County of San Luis Obispo Department of Public Works

CHANGE ORDER TRANSMITTAL

Project: WILLOW RD. EXT. PHASE 2 & RTE 101 INTERCHANGE PROJECT
 Nipomo, California
 Contract No. 300129/300142
 Federal No. NH-Q101(189)E
 EA 05-474504

CCO#: 31 \$50,000.00 Increase

LIMITS OF
SUBGRADE TREATMENT
&
SLOTTED DRAIN LOCATIONS

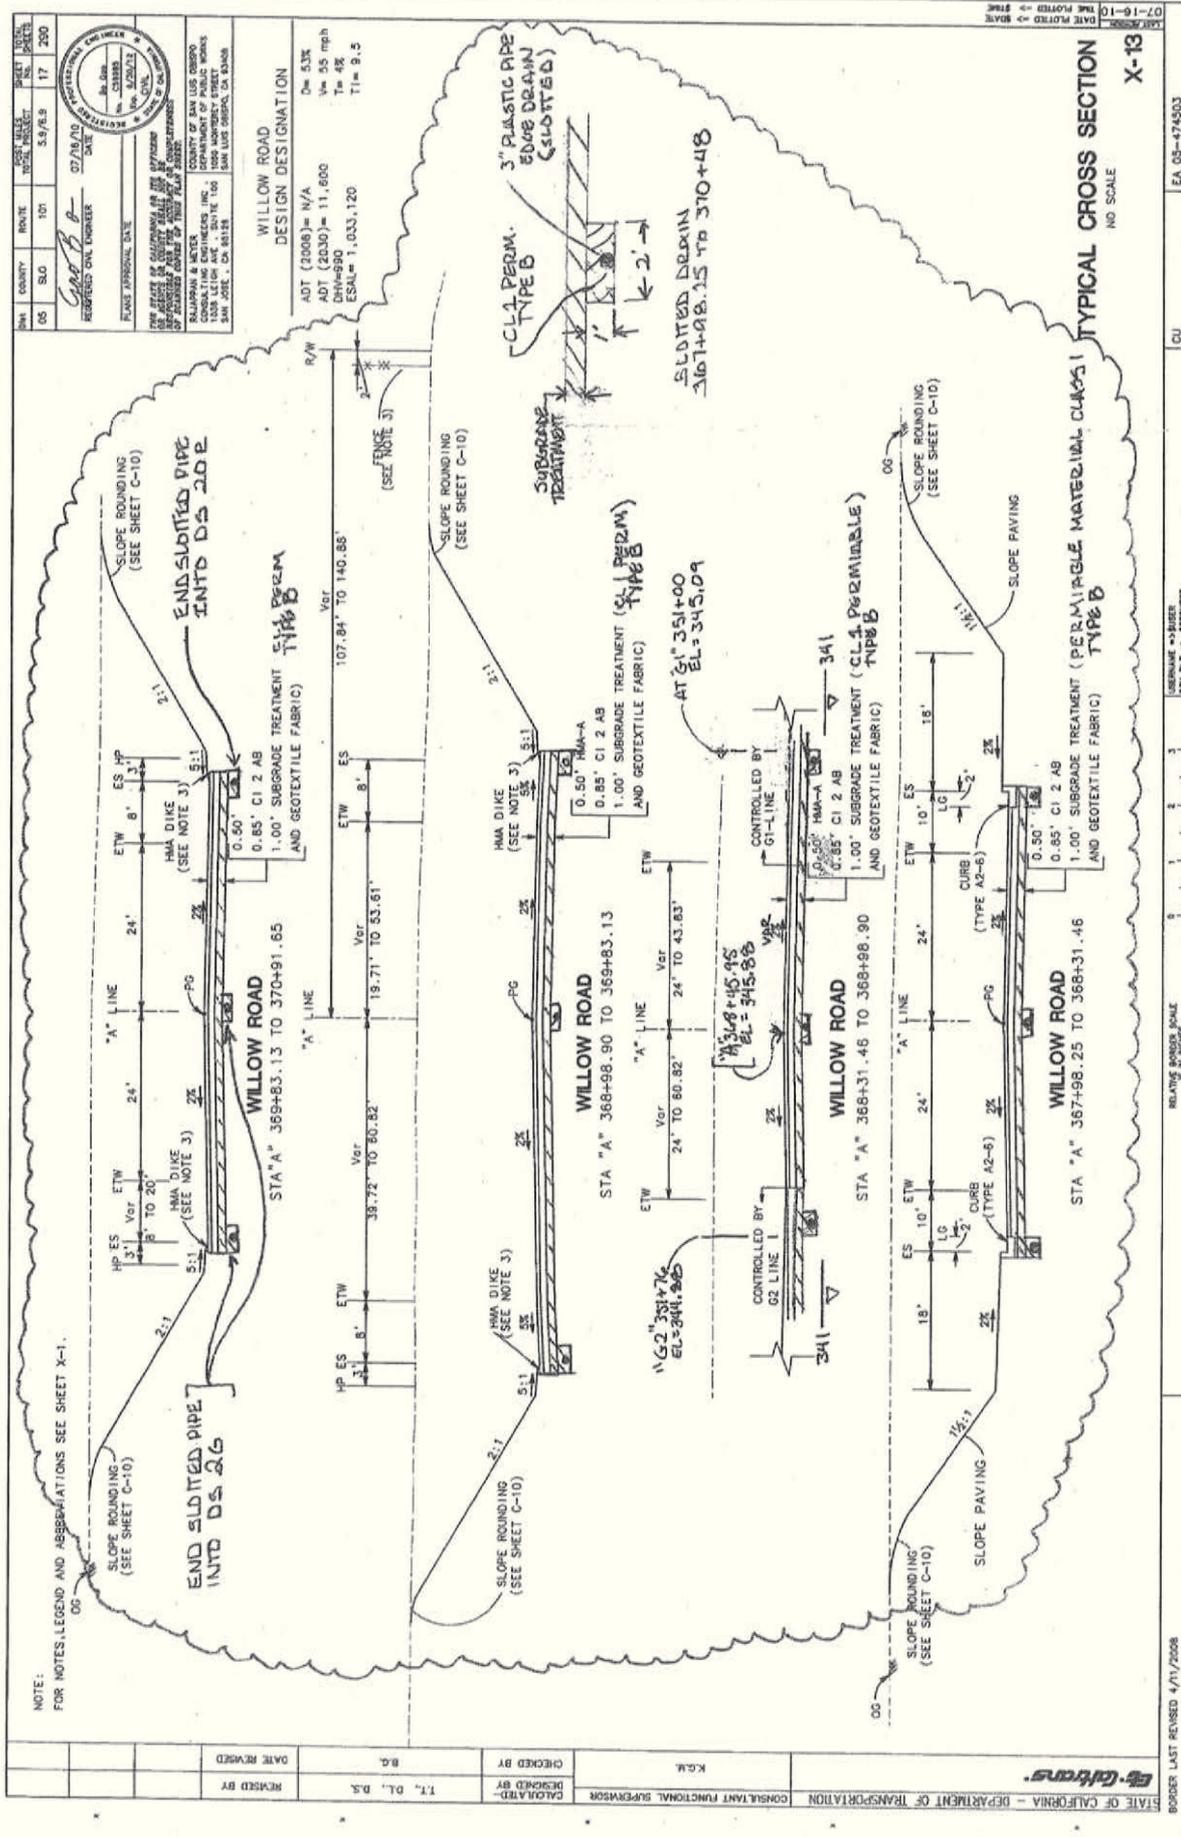
The encountered ground water table at el=341' will be within 0' to 2' of the bottom of the planned structural sections in the areas noted. to prevent existing subsurface ground water from pumping up into the planned roadway structural section the following changes will be made at the locations shown on sheets 3 thru 6 of this CCO

In order to prevent existing subsurface ground water from pumping up into the planned roadway structural section the following changes will be made at the locations shown on sheets 3 thru 6 of this CCO:

- 1) On Contract item #58 (subgrade treatment, CL2AB with Geotextile fabric) Change the planned CL2AB to a CL1, Type B Permeable Base.
- 2) Increase quantity of item #58 to extend placement onto the "G1" and "G2" Ramps as shown on sheets 3 thru 6 of this CCO.
- 3) Install slotted drains as shown on sheet 3 thru 6 of this CCO.
